Bus Priority Infrastructure Program On-time running improvements Castle Hill to M2 Motorway corridor

Submissions report

Roads and Maritime Services | November 2017

Figure 1-3 Detail of proposed changes Locations #6, #7, #9, #10, #11, #12, #13 and #15 as proposed in the REF

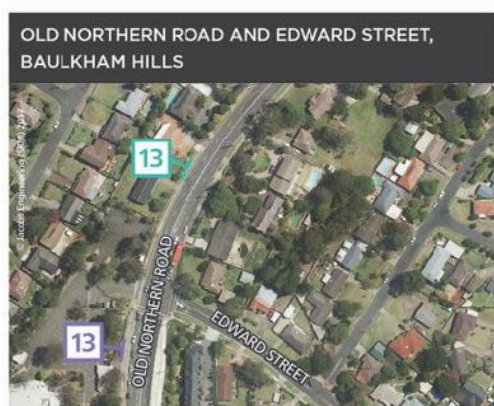
11 Remove bus stop and replace with clearway
12 Remove bus stop and replace with clearway

13 Relocate bus stop and replace with clearway
13 New bus stop replaces no stopping zone

A total of four bus stops are now proposed to be retained in their current location (#11, #12, #13 and #24).
